CITY OF NOVI CITY COUNCIL NOVEMBER 22, 2021

SUBJECT: Initial review of Planned Rezoning Overlay (PRO) eligibility of the request of Grand River Show, LLC, for Holiday Inn, JZ19-24, to rezone from I-1, Light Industrial to TC, Town Center on land located on the south side of Grand River Avenue, east of Beck Road in Section 16. The applicant is proposing to utilize the Planned Rezoning Overlay option to rezone and develop a mixed-use project to include a four-story 117-room hotel and an approximately 16,400 square foot commercial building on approximately 5.5 acres of land. Under the new PRO Ordinance, this initial review by City Council is an opportunity to review and comment on the eligibility of the proposal.

JZ19-24 PRO Concept Plan

4th Revised PRO Concept from I-1 (Light Industrial) to TC (Town Center) with a Planned Rezoning Overlay (PRO)

HOLIDAY INN
DIMENSIONAL PLAN
HOLIDAY INN
SOUTH OF GRAND RIVER, EAST OF BECK ROAD

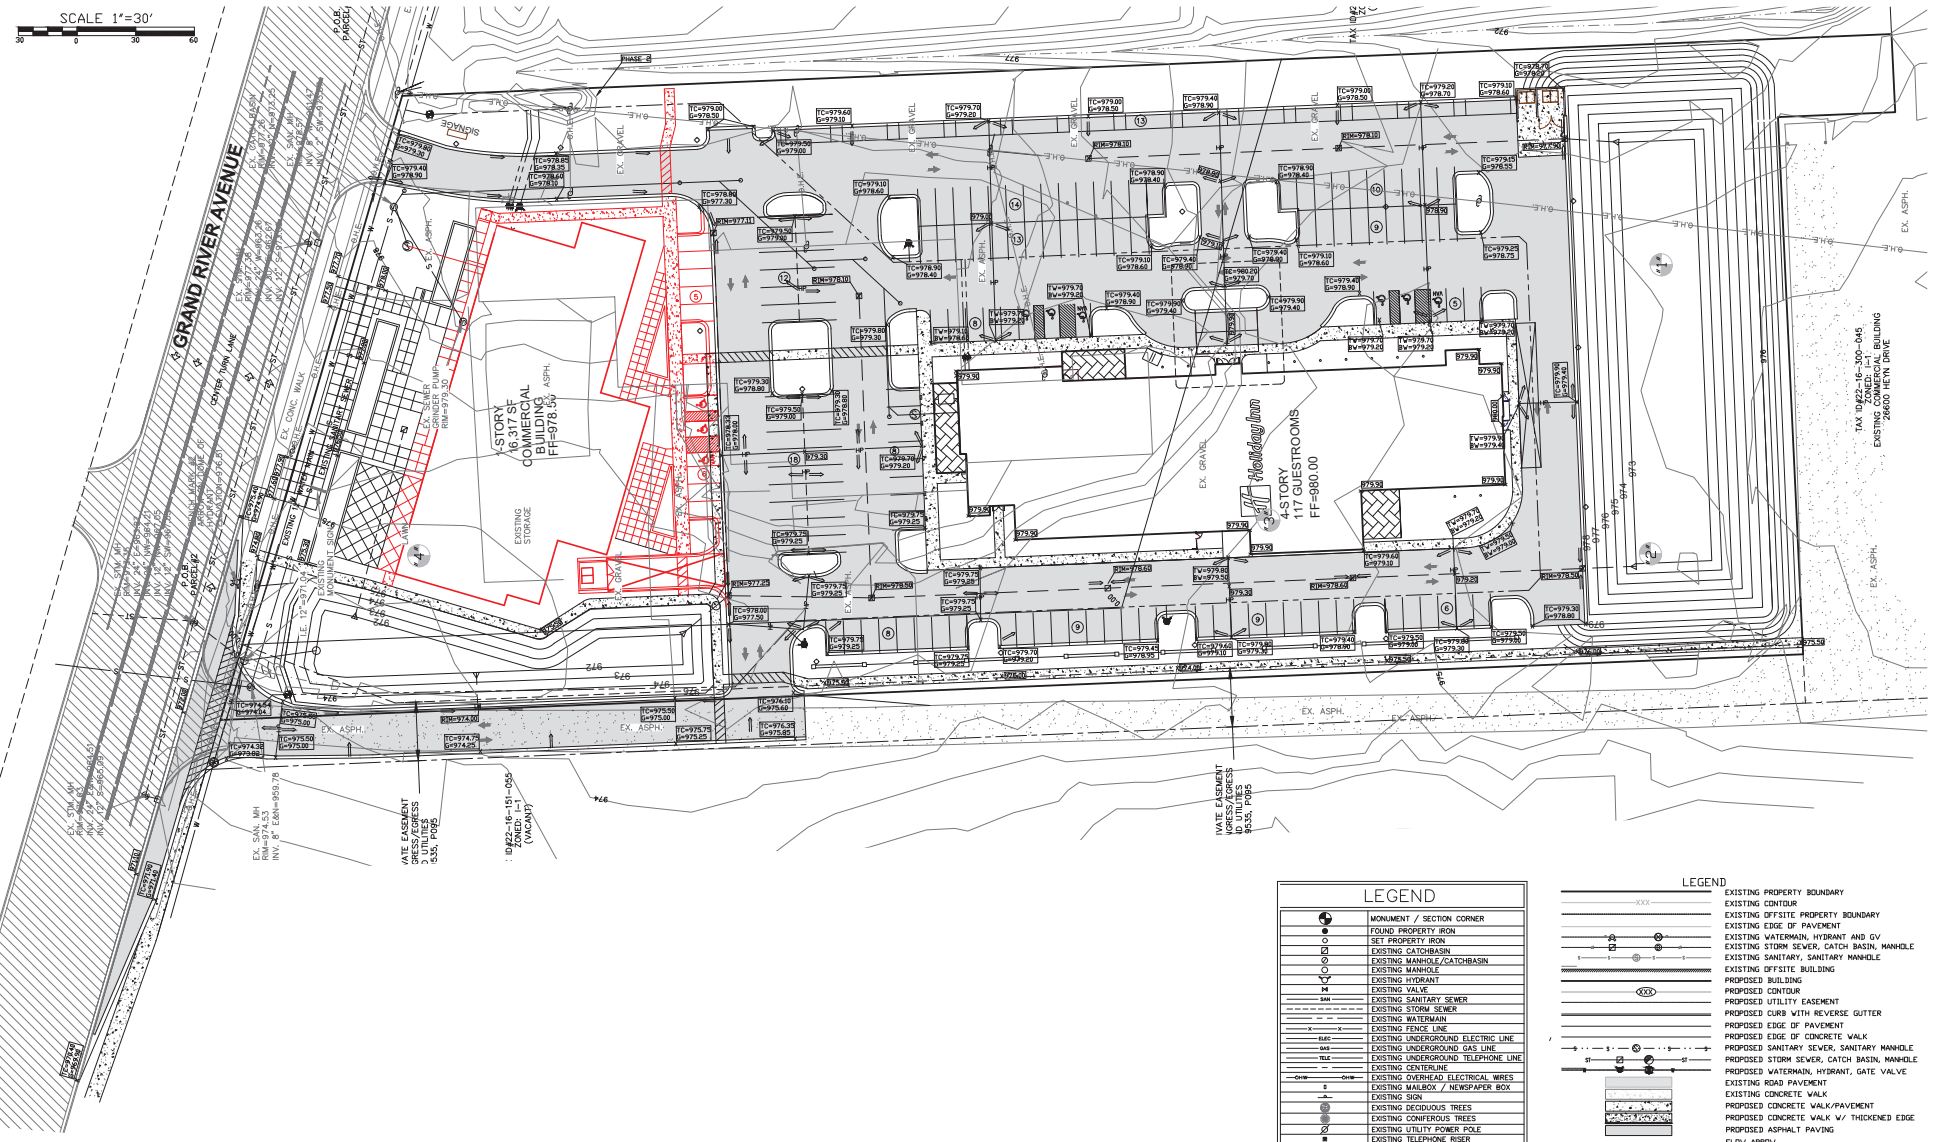
28. Revise the pavement cross sections on sheet S2 to conform to City's Design and Construction standards.
29. Detectable warning plates are required at all barrier free ramps, hazardous vehicular crossings and other areas where the sidewalk is flush with the adjacent drive or parking pavement. The barrier-free ramps shall comply with current MDOT specifications for ADA Sidewalk Ramps. Provide the latest version of the MDOT standard detail for detectable surfaces.

HOLIDAY INN UTILITY PLAN
 HOLIDAY INN
 SOUTH OF GRAND RIVER, EAST OF BECK ROAD

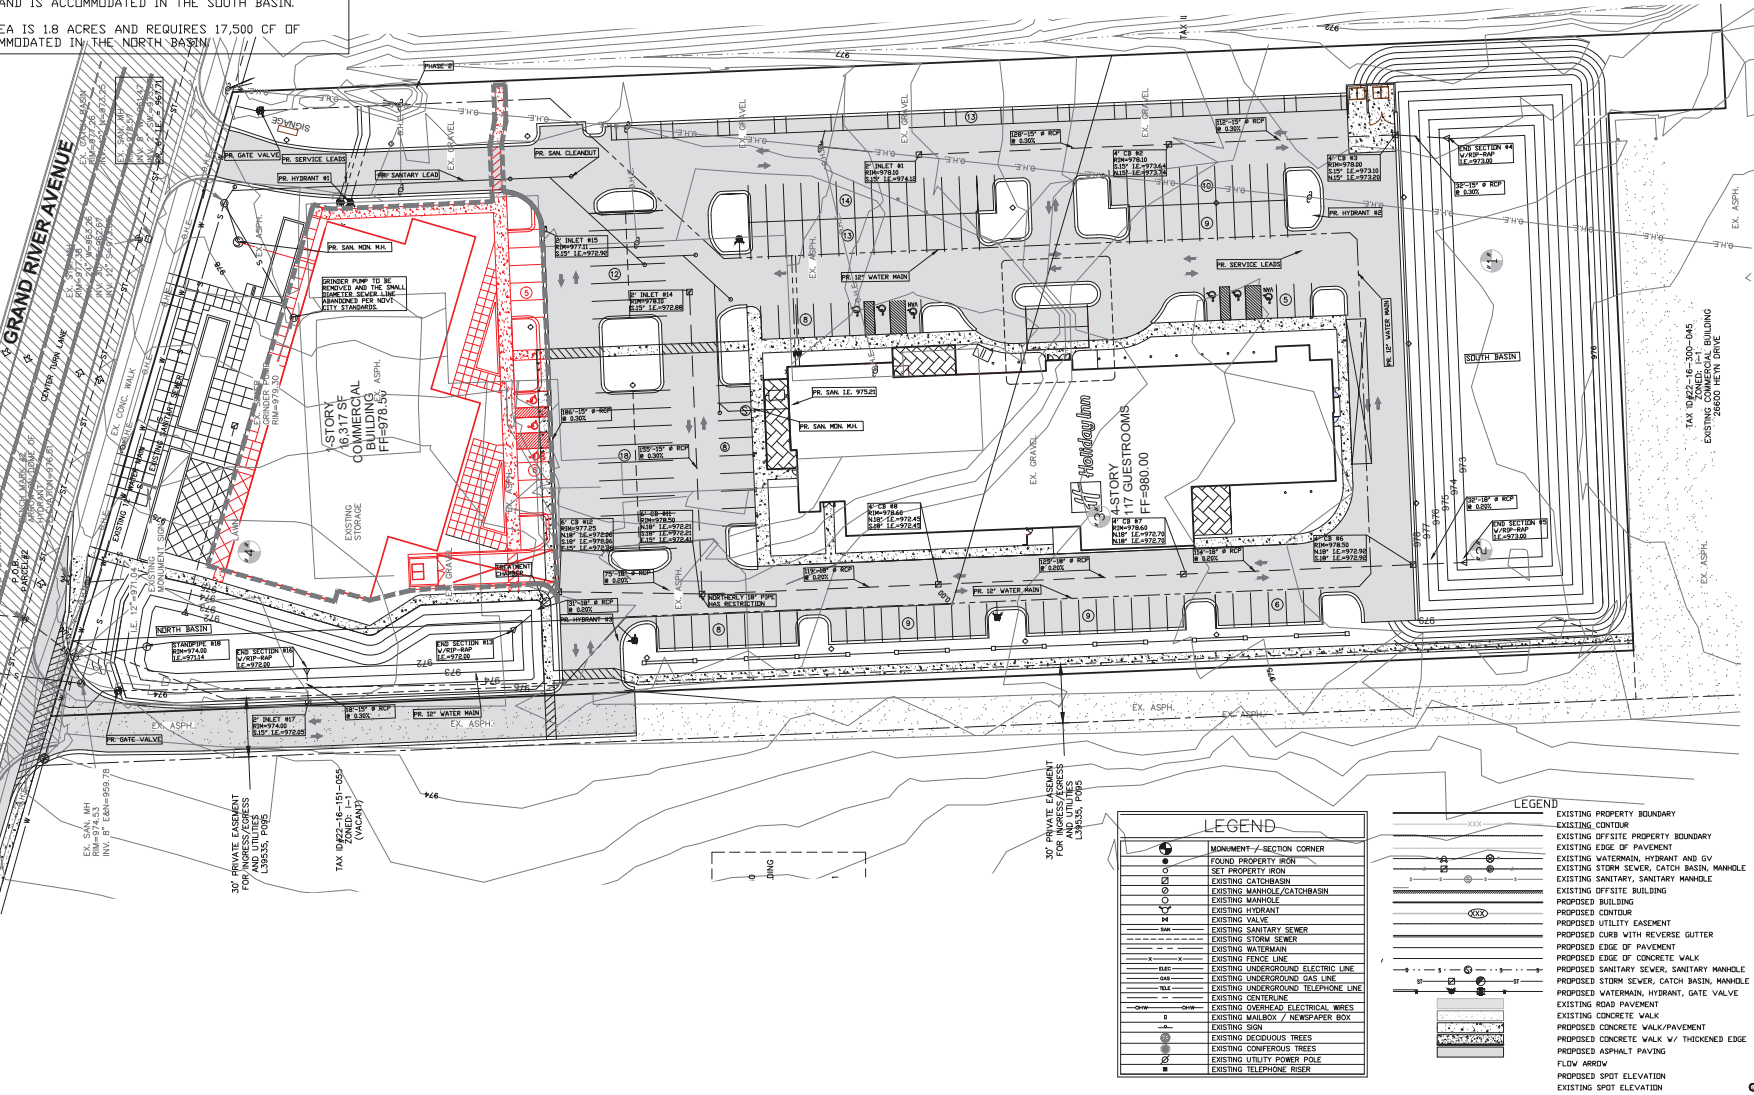
6. The test hole information is noted on sheet S4, but formal soil borings prepared by a geotechnical engineer shall be provided for a preliminary review of the constructability of the proposed development. Borings identifying soil types and groundwater elevation should be provided at the time of Preliminary Site plan.

19. The Storm Water Ordinance requires runoff from the entire development to be detained with post-development discharge restricted to 0.15 cfs/acre. Provide calculations to substantiate this intended agricultural rate noted on sheet S4.

DUMPSTER PAD DETAIL
NO SCALE 10.0'

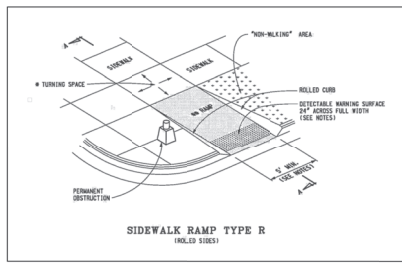
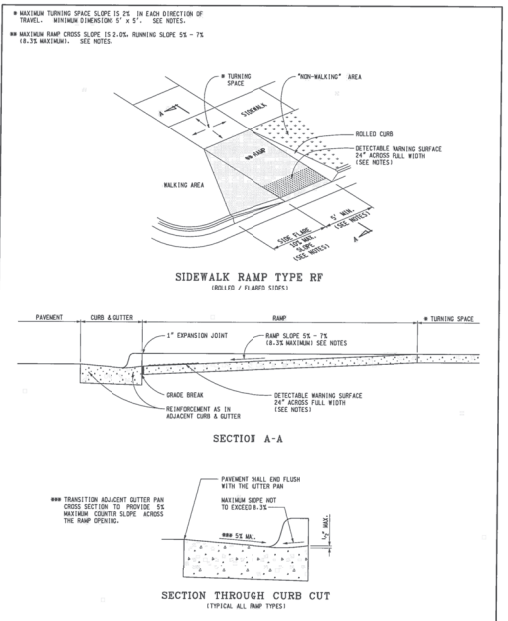
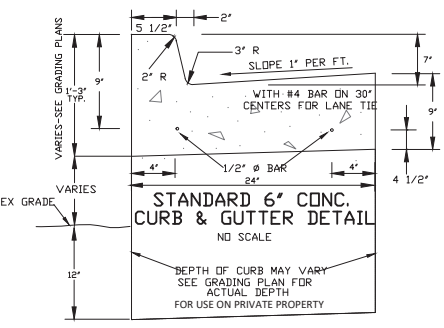
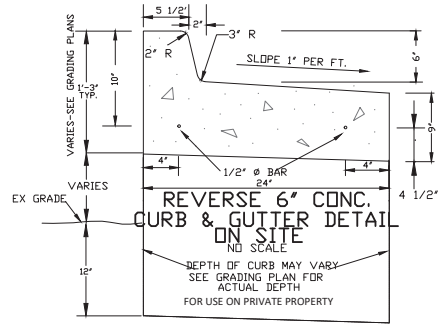
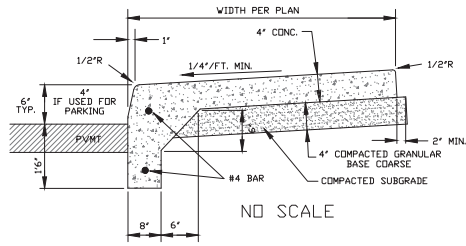
INTERNAL SITE OPERATIONS				
No.	Item	Proposed in the Plan	Compliance	Remarks
20	Parking space front curb height ZO 5.3.2	6" curb	Not Met	17' spaces are only permitted with 4" curb that has a 2' clear overhang. The detail on sheet 5 shows to use 4" for parking but the grading plan shows 6" curb abutting the 17' spaces.
21	Accessible parking – number ADA	9	Met	167 surface parking spaces provided, requiring 6 ADA spaces.
22	Accessible parking – size ADA	Not indicated	Inconclusive	Dimension ADA spaces and aisles
23	Number of Van-accessible space ADA	3 labeled, no dimensions	Inconclusive	3 van accessible spaces indicated, but dimensions are not provided to verify.
24	Bicycle parking			
24a	Requirement ZO 5.16.1	8 spaces provided, 4 at hotel, 4 at shopping center	Not met	Hotels require 4 spaces, as provided. Shopping centers require 2% of parking or 8 spaces, whichever is greater.
24b	Location ZO 5.16.1	2 location indicated	Not met	Spaces at hotel should be located within 120 feet of main entrance.

The detail for the dumpster enclosure on sheet S5 indicates “enclosure material to match the building material”. The dumpster enclosure is also required to be a minimum of 30% brick. Therefore, the note should be revised to read “brick to match the building”.
